PLANNING REPORT

Planning and Zoning Commission

St. John's Memorial Preserve 25-047CP, 25-046Z-PDP

Address	6001 & 6041 Rings Road
Proposal	Rezoning 10.83 acres from R-2, Limited Suburban Residential and R1B (WTWP) to a Planned Unit Development (PUD)
Request	Review and feedback on a Concept Plan and recommendation of Rezoning/ Preliminary Development Plan (PDP)
Zoning	R-2 – Limited Suburban Residential District R1B (WTWP)
Planning Recommendation	<u>Discussion of Concept Plan (CP)</u> <u>Recommendation to City Council of approval of a Rezoning and Preliminary Development Plan with conditions</u>
Next Steps	Upon review and a recommendation of approval of the Rezoning and PDP by the Planning and Zoning Commission (PZC), the applicant will be eligible to move forward with the request to City Council.
Applicant	Dave Guappone, G2 Planning Ernie Robertson and Darlene Becker, St. John's Lutheran Church
Case Manager	Sarah Tresouthick Holt, AICP, ASLA, Senior Planner (614) 410-4662 sholt@dublin.oh.us

Layout

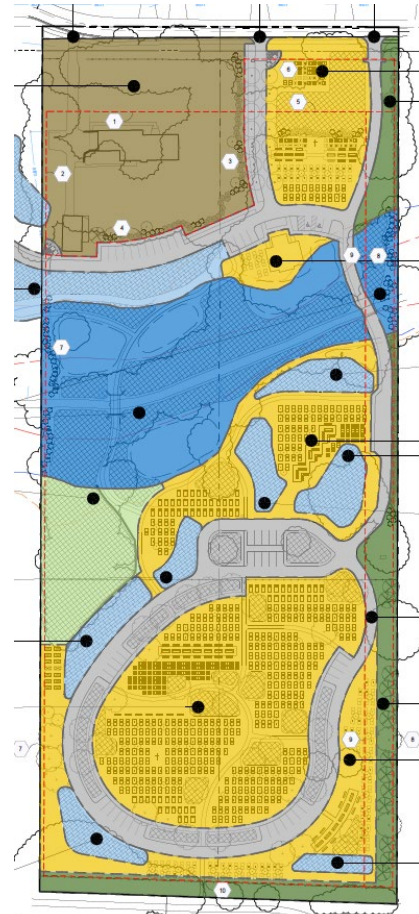
The applicant is showing preservation of the Cramer Ditch floodplain area and related vegetation as an environmental feature and organizing element for the proposal. Buffer areas are located along the eastern edge of the property, adjacent to 5965 Rings Road, and the south edge, adjacent to the City's park.

To provide direct vehicular and pedestrian access from the existing church to the proposed memorial preserve, a new, gated private driveway and walkway is shown from the church parking lot into the subject site. This access leads to a network of private drive loops with occasional parking to serve the various planned memorial areas. Access along Rings Road will also be gated: see more detail in the Transportation and Mobility section. A 5' wide public sidewalk is shown along Rings Road to add to the overall area's pedestrian network.

Moving south, below Cramer Ditch, are additional memorial areas, a preserved natural green space on the west side, and the southern buffer. A small area of additional community gardens is shown along the west edge of the site, just below the natural green space. Most required detention ponds are appropriately located near Cramer Ditch.
